United States Patent and Trademark Office

APPLICATION NO.	FILING DATE	FIRST NAMED INVENTOR	ATTORNEY DOCKET NO.	CONFIRMATION NO.	
09/837,105	04/18/2001	Hajime Kimura	SEL 253	9007	
75	90 04/04/2005	EXAMINER			
COOK, ALEX	, McFARRON, MAN	DONG, DALEI			
CUMMINGS & SUITE 2850	MEHLER, LTD.	ART UNIT	PAPER NUMBER		
200 WEST ADAMS STREET			2879		
CHICAGO, IL 60606			DATE MAILED: 04/04/2005

DETAILED ACTION

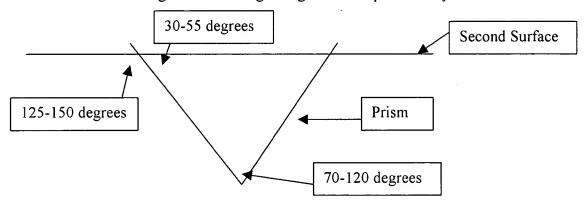
In response to Applicant's argument that the Abe reference fails to teach or suggest an angle between the light scattering body and the second surface is not less than 60 degrees and is less than 180 degrees. The Examiner agrees with the Applicant's assertion that the Abe reference discloses the apex or the uppermost point of the prisms to be between 70 to 120 degrees. Referring to Figure below provided by the Examiner:

As shown in the figure above, Abe reference discloses the apex or the upper most point of the prisms is between 70 to 120 degrees, and because the prisms have a constant pitch, therefore the prism forms an isosceles triangle. The prism and the second surface

forms two angles one is 30-55 degrees and the second angle is 125-150 degrees. The Applicant merely claims an angle between the light scattering body and the second surface is not less than 60 degrees and is less than 180 degrees. Therefore, the Examiner interprets the angle between the light scattering body and the second surface to be the second angle of 125-150 degrees which satisfies the claimed range of angles. Thus, the Examiner asserts that the Abe reference teaches the claimed invention and maintains the rejection.
